Client:	Portland Nurseries
Project:	Portland Nursery, Honley
Our ref:	P1246
Date:	February 2020

This Technical Note will set out the response to the Kirklees Council's (KC) comments on the planning application for the proposed nursery at the Former Eastgate Depot, Honley, Holmfirth, HD9 6PA (ref: 2019/93790). The KC comments are centred upon 2 main issues - parking and visibility; both in terms of vehicles entering the site, and pedestrians crossing the road on Eastgate. This note addresses each issue in turn.

Figure 1 – Location of additional car parking capacity

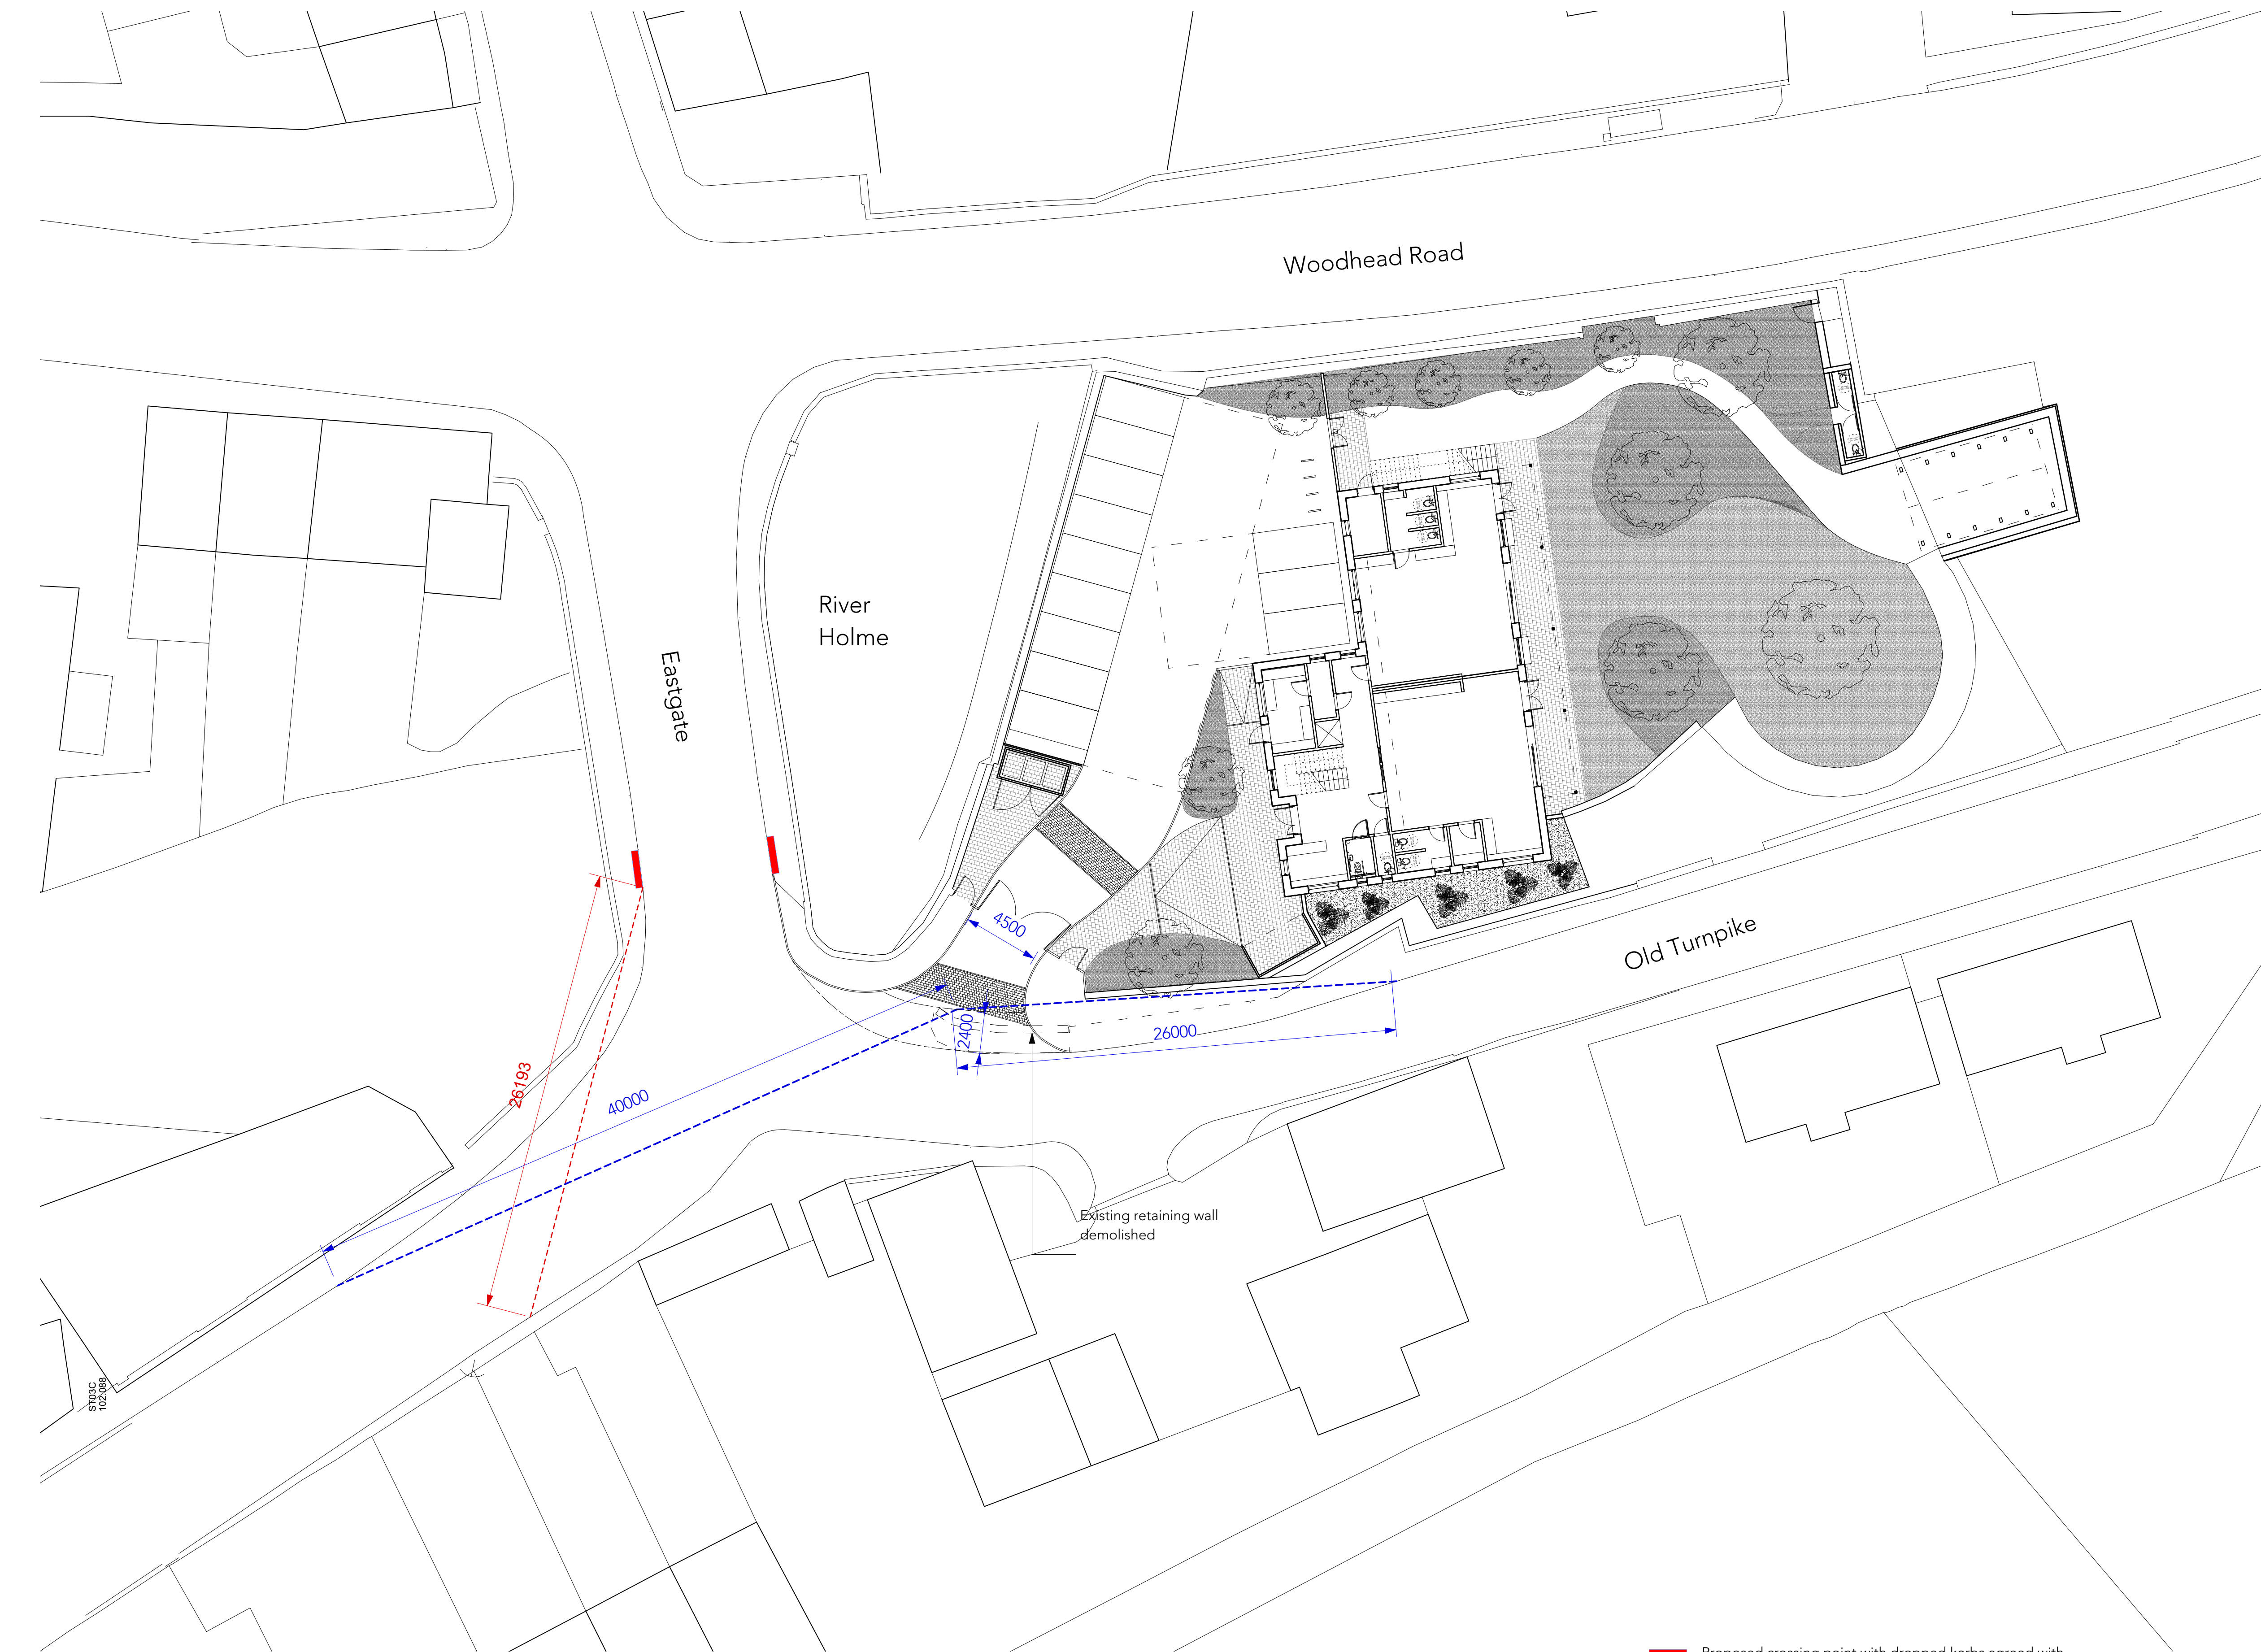
It should also be noted that positive discussions have taken place with a local business. Balooshai Indian restaurant is less than 0.2 miles from our site, as shown in **Figure 1** and have

confirmed they will allow nursery staff to use their car park. The restaurant opens at 5pm and the owners are happy for staff to use their car parking facilities until then. Based on staff rotas for a similar sized nursery at Oakwood House, 10-14 staff who would finish work before 5.00pm and therefore the restaurant car park has enough spaces for staff to park there, if required.

Several verbal discussions have taken place with the owners of the restaurant and at present written confirmation is awaited. Once this confirmation has been received it will be emailed to the relevant KCC officers.
